## 3.2 65 Kooyongkoot Road, Hawthorn - Two Dwellings on a Lot

**Application no.:** PP22/0002  
**Responsible director:** Scott Walker, Director Urban Living  
**Authorised by:** David Cowan, Manager Planning and Placemaking  
**Report officer:** Amaya De Silva, Senior Statutory Planner

## STATUTORY PLANNING DELEGATE REPORT

PRIVACY SCREEN DETAIL 1:25

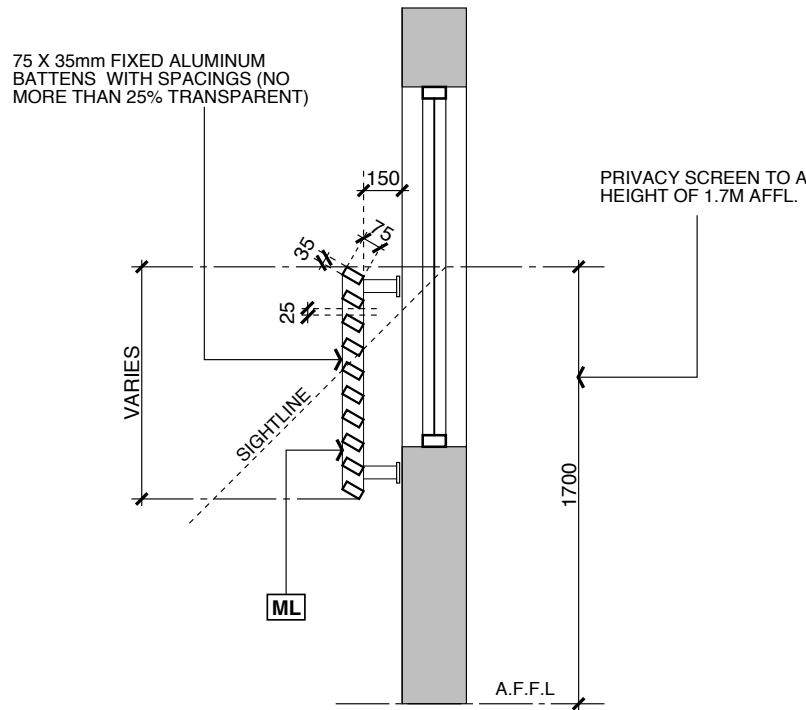
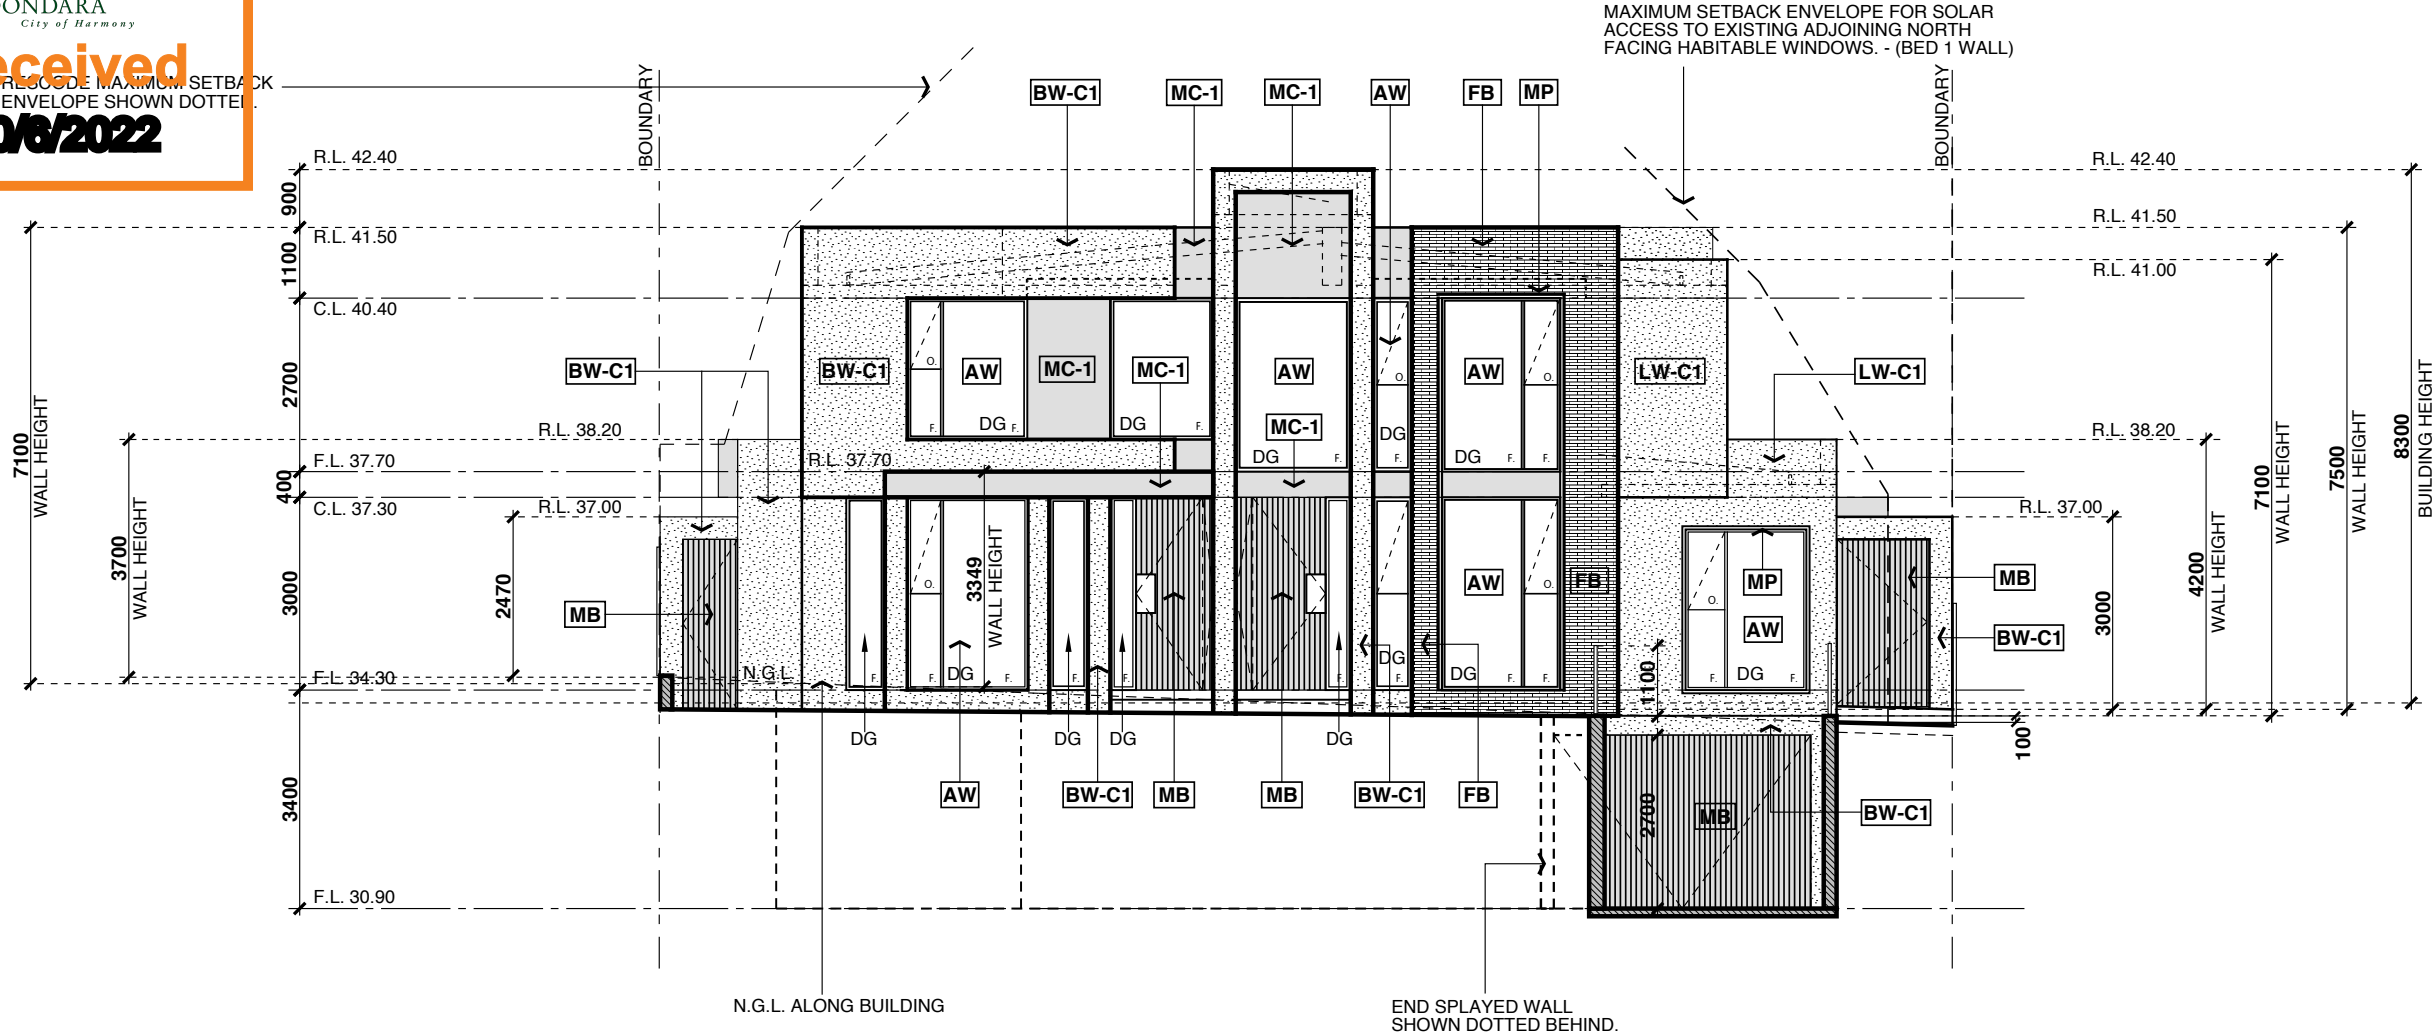
With respect to Overlooking, the elevations have details included showing screening, with the floorplans indicating these screens as “privacy screens”. To ensure this is clearly compliant with Clause 55.04-6 (Overlooking), a condition is recommended to have a notation on each of the windows that the window will be screened in accordance with Clause 55.04-6.

- Details of all external privacy screening indicated on the plans and elevations (including a cross-section at a scale of 1:50 if required), demonstrating compliance with Standard B22 of Clause 55.04-6;

- d. The southern setback of the sauna and adjacent bathroom associated with Dwelling 1 increased to 2.5 metres;
  - e. Details of all external privacy screening indicated on the plans and elevations (including a cross-section at a scale of 1:50 if required), demonstrating compliance with Standard B22 of Clause 55.04-6;

2. WEST ELEVATION 1:50  
KOOYONGKOOT ROAD STREET VIEW.

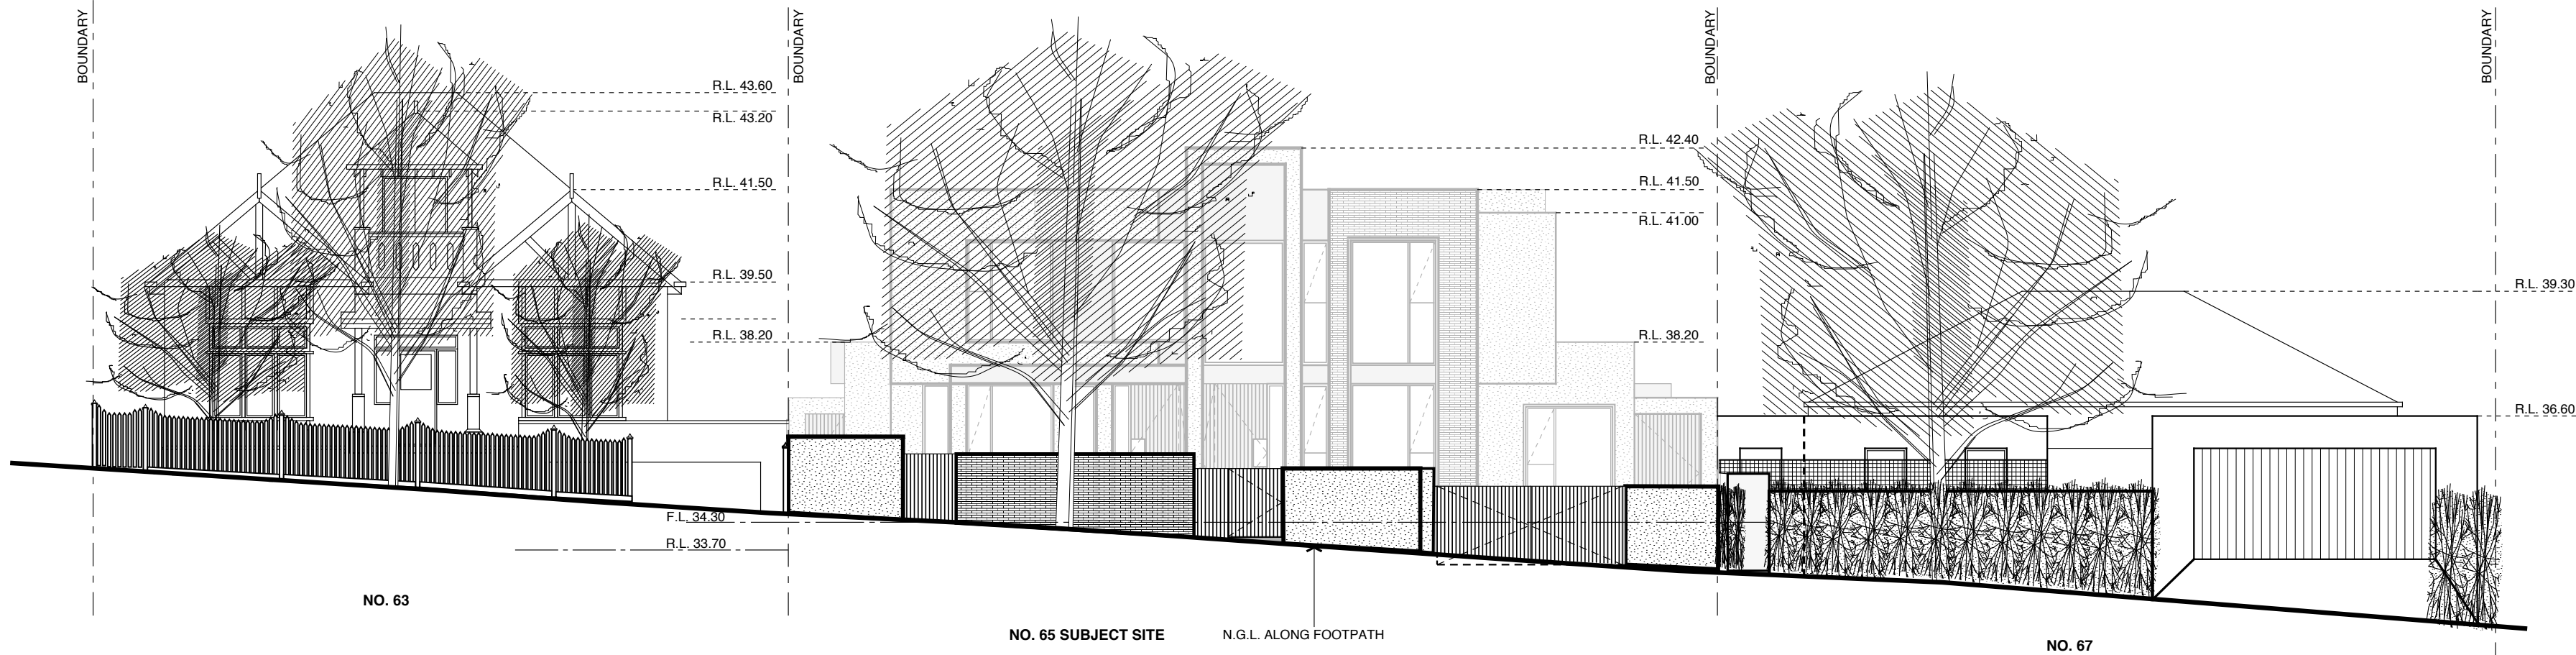
It is noted the Precinct Statement seeks to maintain views of front gardens. For the proposal, the fence is comprised of three different materials, including brick render, face brick and metal gates. This provides sufficient articulation and visual interest to the streetscape. To allow for further views to the front garden however, a condition will be recommended to include metal infill (similar to that of the gates) directly opposite the porch and entry area of Dwelling 2. This is highlighted in yellow in the plan and render below:

The Officer has required: "the masonry wall south of the drive way will need to be at least 50% permeable to a depth of 150mm". A condition is therefore recommended to revise this portion of the fence to be metal infill to match the adjacent vehicular gate. This will also help to alleviate concerns of visibility and permeability of the fence as discussed above.

- a. The masonry portion of the front fence directly opposite the porch and entry area of Dwelling 2 to be revised and shown as metal infill to match the pedestrian gates;

- b. The central dividing fence between the two dwellings at the front of the site reduced in height to a maximum 1.8 metres;
  - c. The masonry portion of the front fence to the south of the driveway to be revised and shown as metal infill to match the pedestrian and vehicular gates;
